Re: Ripley Street Development, Project Plan No. 9-040006

Re: Ripley Street Development Project Plan Number #9-04006

SUBJECT: Project Plan Review No. 9-04006  
Ripley Street Condominiums

SUBJECT: Project Plan No. 9-04006  
Ripley Street Development  
Silver Spring CBD

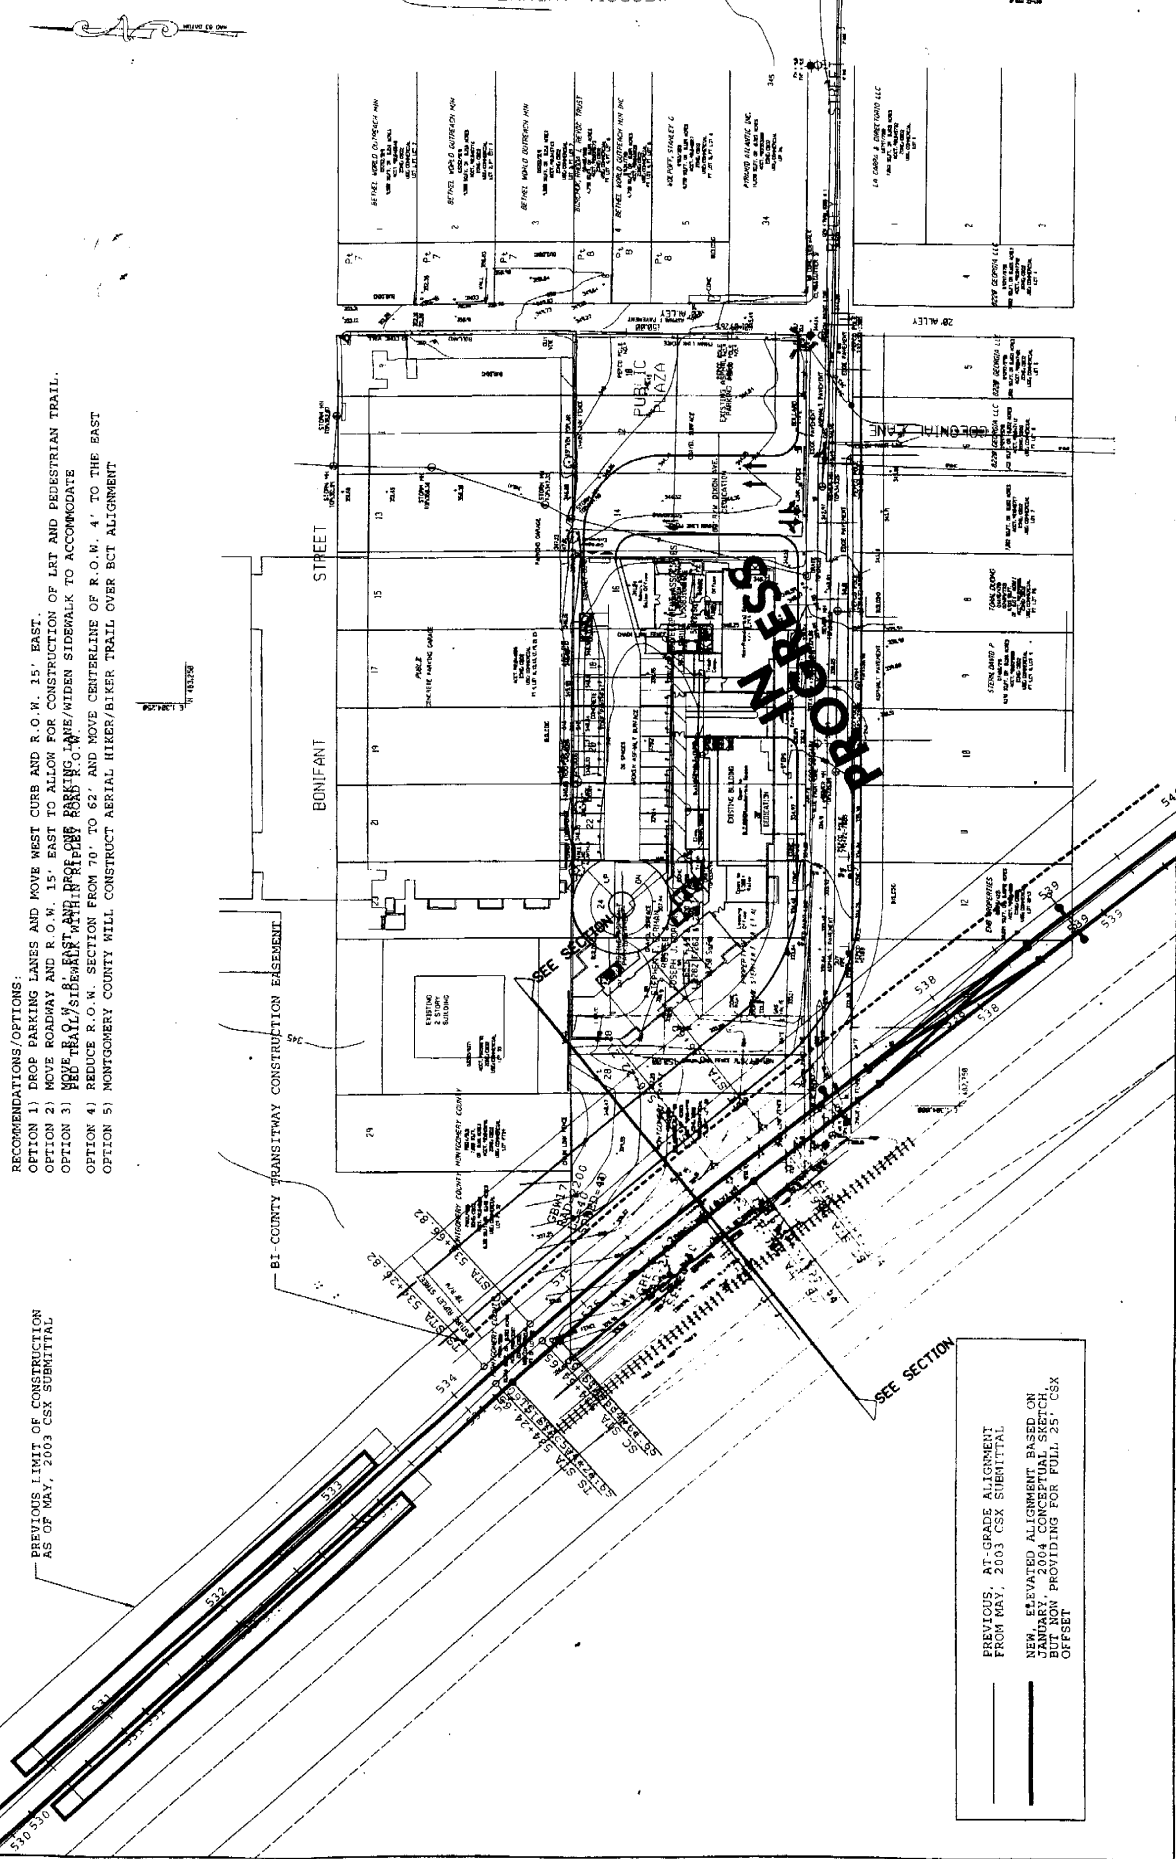
- RECOMMENDATIONS/OPTIONS:
- OPTION 1) DROP PARKING LANES AND MOVE WEST CURB AND R.O.W. 15' EAST.
  - OPTION 2) MOVE ROADWAY AND R.O.W. 15' EAST TO ALLOW FOR CONSTRUCTION OF LRT AND PEDESTRIAN TRAIL.
  - OPTION 3) ~~WIDEN SIDEWALK TO ACCOMMODATE~~ ~~WIDEN SIDEWALK TO ACCOMMODATE~~ ~~WIDEN SIDEWALK TO ACCOMMODATE~~
  - OPTION 4) REDUCE R.O.W. SECTION FROM 70' TO 62' AND MOVE CENTERLINE OF R.O.W. 4' TO THE EAST
  - OPTION 5) MONTGOMERY COUNTY WILL CONSTRUCT AERIAL HIKER/BIKER TRAIL OVER BCT ALIGNMENT

PREVIOUS LIMIT OF CONSTRUCTION  
AS OF MAY, 2003 CSX SUBMITTAL

PREVIOUS AT-GRADE ALIGNMENT  
FROM MAY, 2003 CSX SUBMITTAL

NEW, ELEVATED ALIGNMENT BASED ON  
JANUARY, 2004 CONCEPTUAL SKETCH  
PROVIDING FOR FULL 25' CSX  
OFFSET

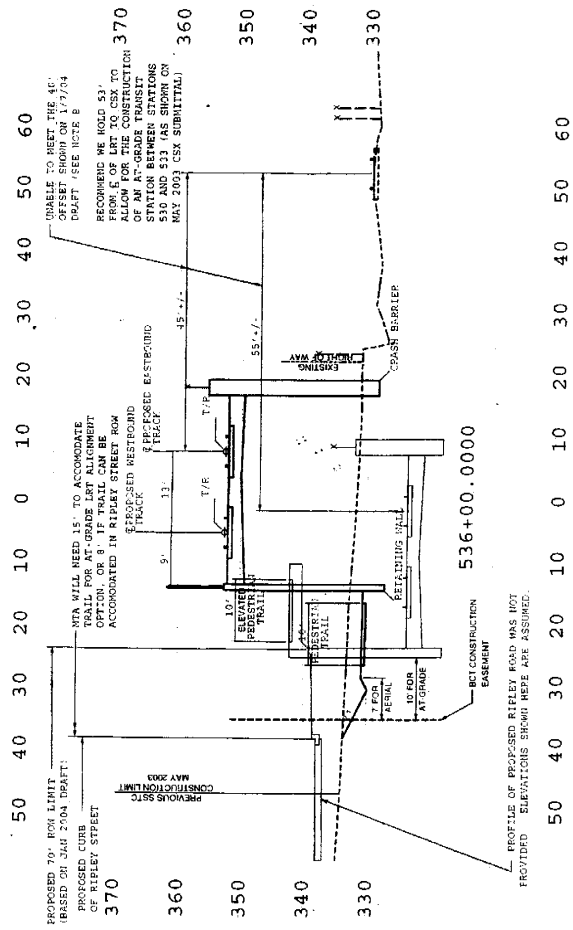
- Ⓐ THE LRT SECTION SHOWN IN BLACK IS BASED ON THE AT-GRADE LRT ALIGNMENT INITIALLY SUBMITTED TO CSX (SINGLE TRACK AT METRO PLAZA). THIS ALIGNMENT RESULTS IN THE STATION PLATFORM TO BE LOCATED BETWEEN STATIONS 530-7' AND 533'. THIS SHEETING THE LRT TRACK FURTHER AWAY FROM CSX IN THIS LOCATION TO AVOID IMPACTING THE EXISTING MARC PLATFORMS).

- Ⓑ PLEASE NOTE THE 40' OFFSET SHOWN ON THE 1-07-04 "DRAFT" PLAN WAS BASED ON A \$10 MILLION AERIAL ALIGNMENT WHICH ALLOWED THE LRT STATION PLATFORMS TO BE LOCATED ADJACENT TO COLESVILLE ROAD BY ASSUMING AN 18' OFFSET FROM SUPPORT COLUMNS TO CSX. A SIMILAR ALIGNMENT, HOLDING 25' OFFSET FROM SUPPORT COLUMNS TO CSX RESULTS IN A 45' TRACK OFFSET FROM CSX. THIS ALIGNMENT WOULD BE GOING TO A RETAINED FILL SECTION IN THIS AREA. THIS LOSS CAN BE PARTIALLY OFFSET BY GOING TO 13' TRACK CENTERS (FROM 17'-1" REQUIRED ON AERIAL STRUCTURE).

- Ⓒ MTA SHOULD MAINTAIN THE ABILITY TO CONSTRUCT THE TRANSITWAY AND TRAIL "AT GRADE ALIGNMENT" THIS ALIGNMENT, IF APPROVED BY CSX, COULD REDUCE CONSTRUCTION COSTS BY APPROXIMATELY \$10 MILLION.

- Ⓓ RECOMMENDATIONS/OPTIONS:
  - OPTION 1) DROP PARKING LANES AND MOVE WEST CURB AND R.O.W. 15' EAST.
  - OPTION 2) MOVE ROADWAY AND R.O.W. 15' EAST TO ALLOW FOR CONSTRUCTION OF LRT AND PEDESTRIAN TRAIL.

- OPTION 3) MOVE R.O.W. 8' EAST AND DROP ONE PARKING LANE/HIDDEN SIDEWALK TO ACCOMMODATE PED. TRAIL/SIDEWALK WITHIN RIPLEY ROAD R.O.W.
  - OPTION 4) REDUCE R.O.W. SECTION FROM 70' TO 63' AND MOVE CENTERLINE OF R.O.W. 4' TO THE EAST

- OPTION 5) MONTGOMERY COUNTY WILL CONSTRUCT AERIAL RIZER/TRAIL OVER BCT ALIGNMENT
